Date of Notice: (DD/MM/YYYY)	13/07/2017	Product Change Notice Number:	USB3140 D PCN 20170713
------------------------------	------------	-------------------------------	------------------------

Product Identifier:	USB3140-30-XXXX-X-C
---------------------	---------------------

Drawing Revision Letter:	D	Effective from date code/batch code:	New POs. (Existing POs will be shipped against Rev C)
--------------------------	---	--------------------------------------	---

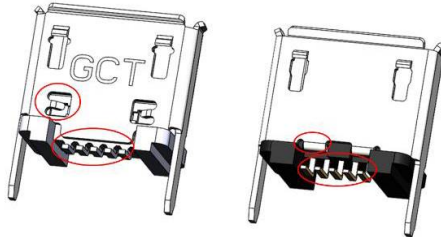
1. Change in solder tail width & length from 0.25 to 0.30mm, 1.50 to 1.18mm & housing dimension from 3.40 to 4.00mm:

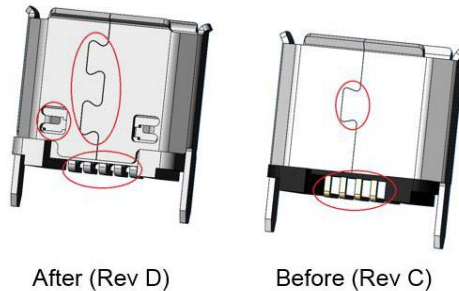
2. Change in shell & housing structure (Illustration below shows Shell stake 2.3mm version):
